Mt. Hope High School
Bristol, RI
Pare Project No. 23099.01

February 11, 2025
Page 1 of 8

**RESPONSES TO BETA PRELIMINARY PLAN PEER REVIEW COMMENTS DATED
JANUARY 24, 2025**

DRAWING NO.: C7.3

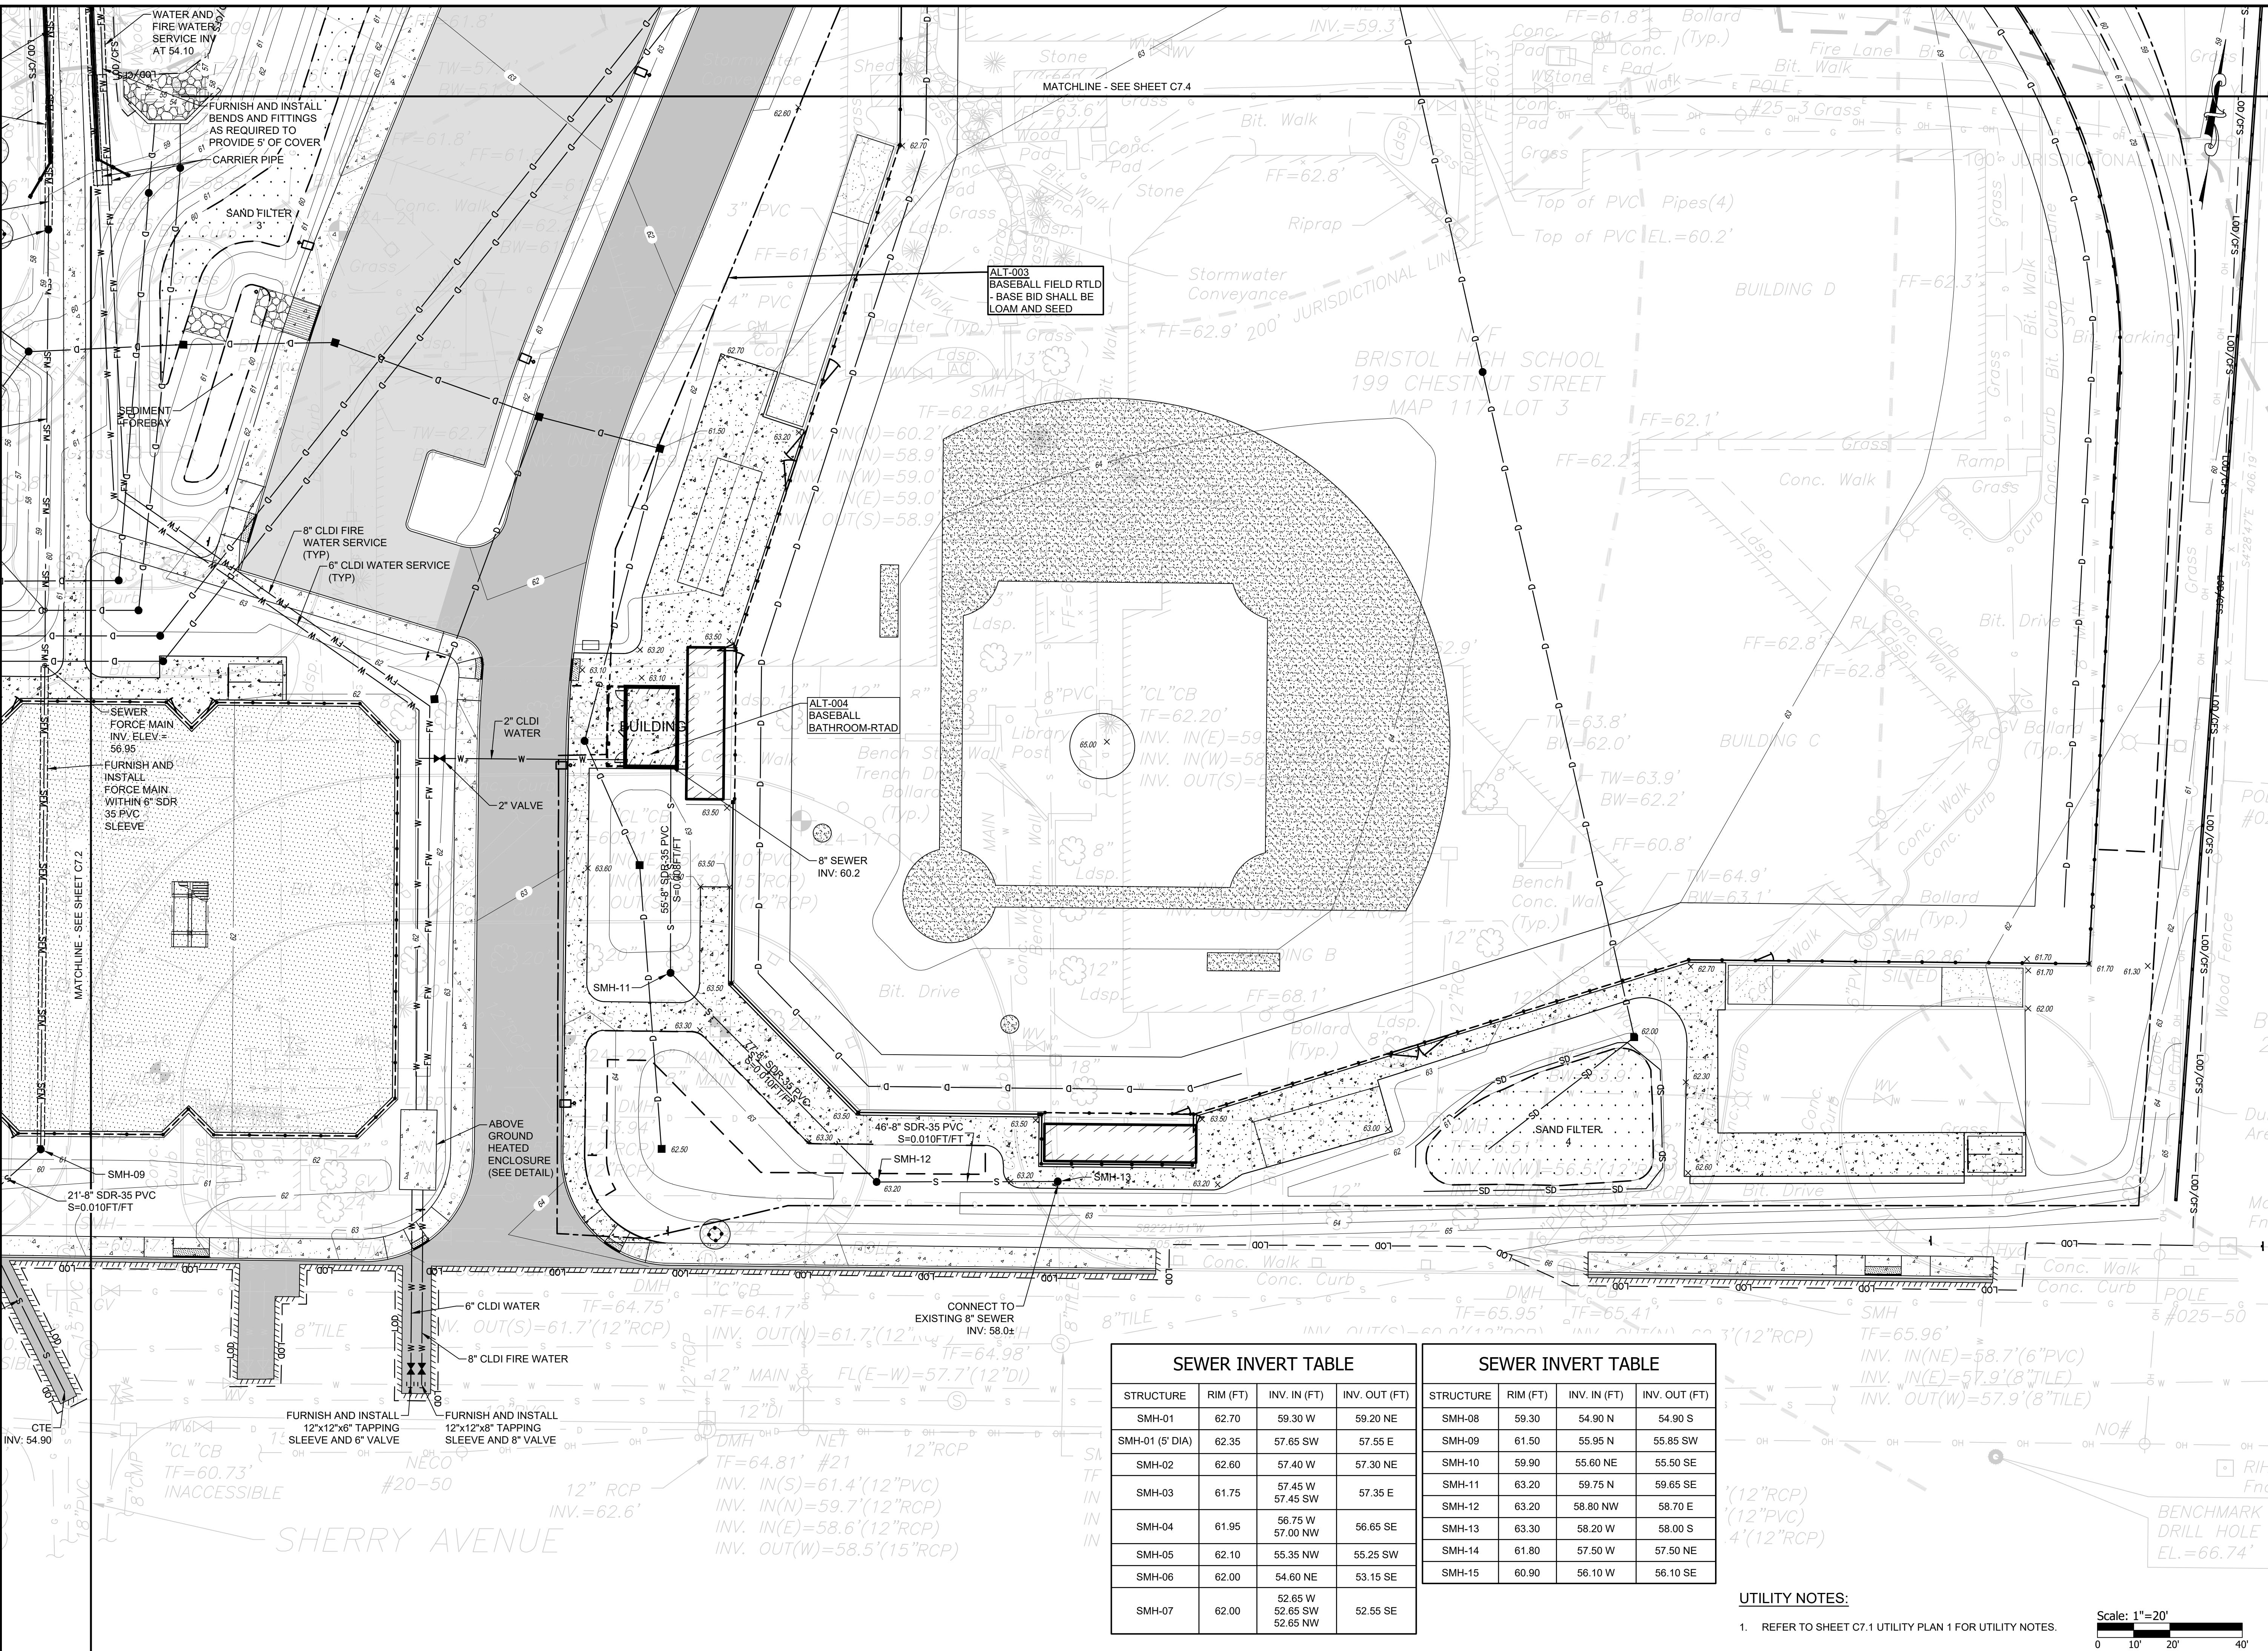
- RESPONSE:** Pare requested meeting with BWPC to coordinate force main and gravity sewer layout and discharge location.
- 10) **COMMENT:** Minimum size of gravity sewer pipe is 8-inch (Review SMH-09 to SMH-10 to Exis).

14) **COMMENT:** Compare elevation to SSO location near bridge.

15) **COMMENT:** Provide Backflow Preventer.

- RESPONSE:** Sewer services have been updated to be 8" SDR-35 PVC pipe, please refer to C7.2 and C7.3.
- 11) **COMMENT:** Provide rim elevation of existing sewer manhole on pedestrian bridge (Note this is a current low point and a current sanitary sewer overflow location) and compare to other rim elevations.

RESPONSE: Pare requests additional information regarding SSO and guidance from Peer Reviewer and BWPC.

RESPONSE: Pare requests additional information regarding SSO and guidance from Peer Reviewer and BWPC.
